LUSCOMBE AIRPLANE CORPORATION
West Trenton, New Jersey

ENGINEERING BULLETIN #12

REF: Model 8A with injector engines.

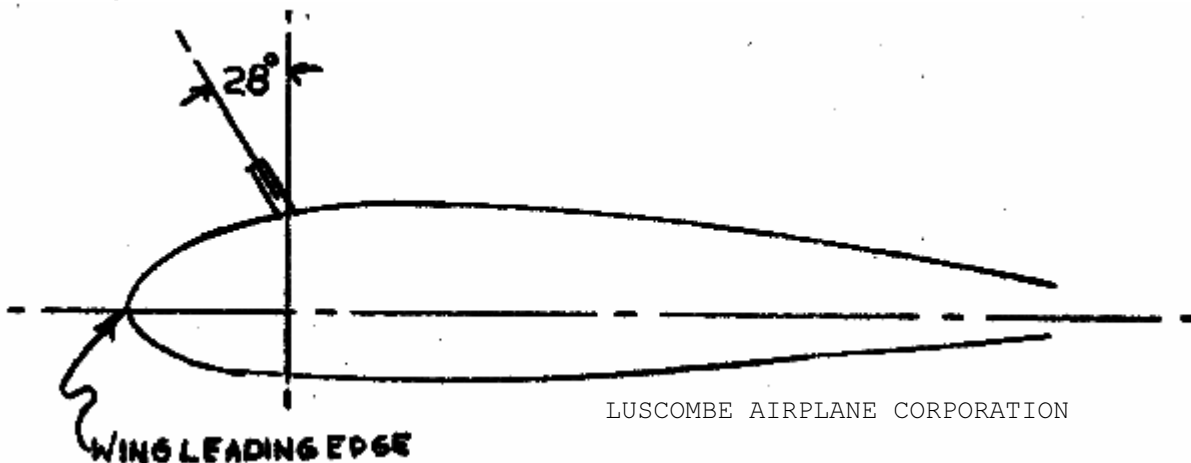
Cut vent line 2" from 90° elbow at gascolator. Make flexible joint in line at this point with 1/4 I.D. Neoprene hose 4" long. Use hose clamps to fasten nose to tube, as in sketch A.

Bend the vent line forward 28° from perpendicular at the outlet in the leading edge of wing, as in Sketch B.
